ALERT SERVICE BULLETIN

429-19-47

Revision A, 2 November 2020

SUBJECT: TAIL ROTOR GEARBOX SUPPORT RETAINING RIVETS, INSPECTION OF.

Figure 1 – Rivet Identification

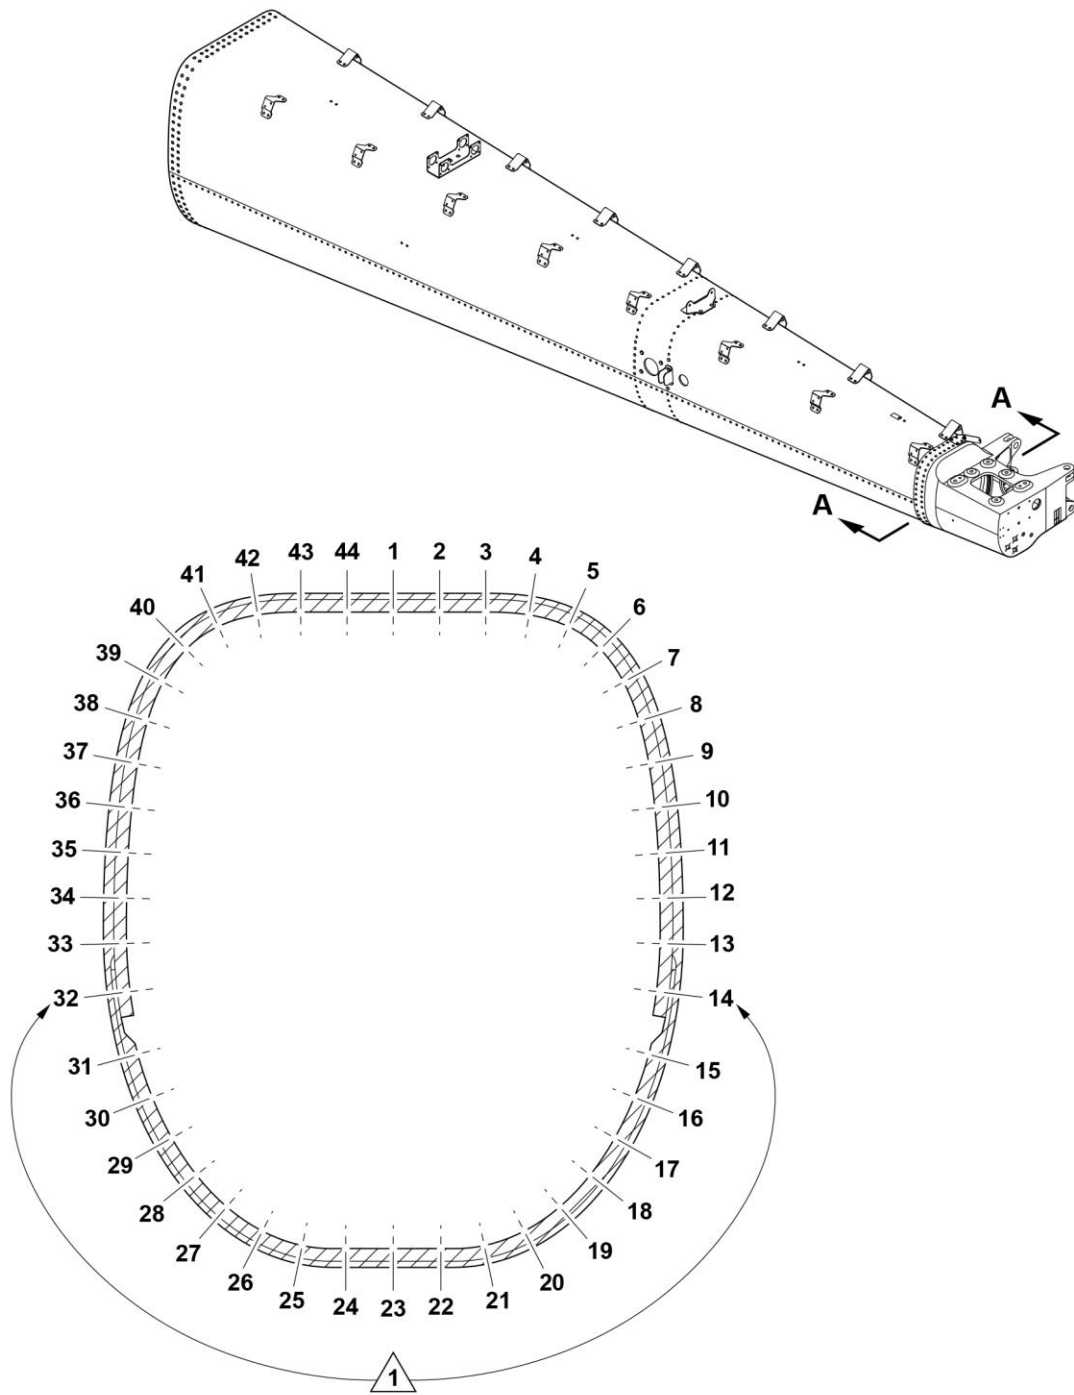
7. Do a tactile check of all the rivets identified in Figure 1 by pulling on each rivet tail.

8. Using Figure 1 to identify the position of the rivets, note the position of any discrepant rivet found during steps 5, 6, and 7 in Table 1.

Perform tactile check on indicated rivet tails.
